Access Compliance Report Public Rights-of-Way (Curb Ramps)

Main Street: E_KIRKWOOD_AVE Cross Street: S_NEWHAVEN_DR Location: SE

ADA ID: RPRK211006180726 Ramp Type: Type 1 - Perpendicular Diagonal Initial Pass/Fail: Fail Overall Compliance: No Severity Score: 15

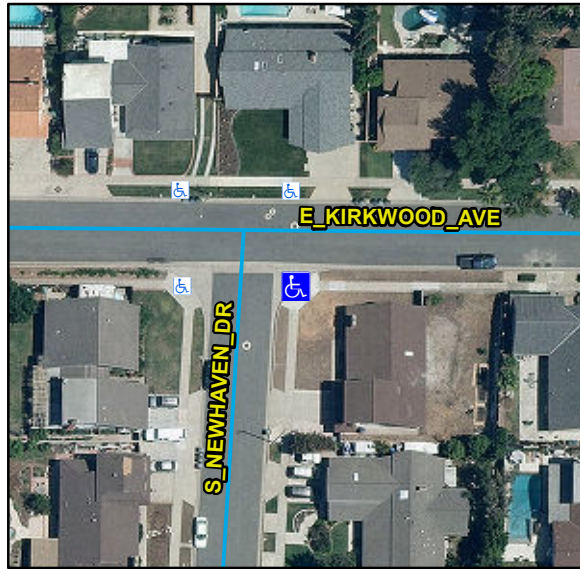
Compliance	Description	Data	Compliance	Description	Data
N/A	Ramp Length (in)	121	N/A	Flare Type LT	
Yes	Ramp Width (in)	48			N/A
No	Ramp Run Slope (%)	11.2	N/A	Flare Slope LT (%)	N/A
Yes	Ramp Cross Slope (%)	0.6	N/A	Flare Traversable LT	N/A
N/A	Landing Present	N/A	N/A	Flare Type RT	
N/A	Landing Length (in)	N/A			N/A
N/A	Landing Width (in)	N/A	N/A	Flare Slope RT (%)	N/A
N/A	Landing Run Slope (%)	N/A	N/A	Flare Traversable RT	N/A
N/A	Landing Cross Slope (%)	N/A	N/A	DWS Provided	N/A
N/A	Landing Movement Obstructed?	N/A	N/A	DWS Contrast	N/A
	Landing Movement Type	N/A	N/A	DWS Length (in)	N/A
N/A	Landing Shared	N/A	N/A	DWS Full Width	N/A
N/A	Clear Space	Yes	N/A	DWS Offset Left (in)	N/A
N/A	Clear Space To Crosswalk (in)	N/A	N/A	DWS Offset Right (in)	N/A
N/A	Marked Crosswalk 1	No	N/A	Marked Crosswalk 2	No
	Crossing 1 Direction	N		Crossing 2 Direction	W
	Marked Crosswalk 1 Width (in)	N/A		Marked Crosswalk 2 Width (in)	N/A

N/A	Ramp Inside Crosswalk 1	N/A	Yes	Ramp Inside Crosswalk 2	N/A
	Crossing 1 Slope (%)	11.5		Crossing 2 Slope (%)	1.9
	Crossing 1 Cross Slope (%)	4.5		Crossing 2 Cross Slope (%)	0.7
N/A	Gutter Ponding	N/A	No	Curb Slope	17.4
Yes	Gutter Lip Height (in)	0		Road Run Slope (%)	3.2
N/A	Gutter Run Slope (%)	N/A		Road Cross Slope (%)	8
N/A	Gutter Cross Slope (%)	N/A			
Yes	Overall Surface Condition: Acceptable		Yes	Perp Joint Present	Yes
	Cross Gutter Present?	Yes		Spandrel Present?	Yes
	Replace Cross Gutter?	No		Replace Spandrel?	No

Remove & Replace Curb Ramp With Two New Directional Ramps or Equivalent.
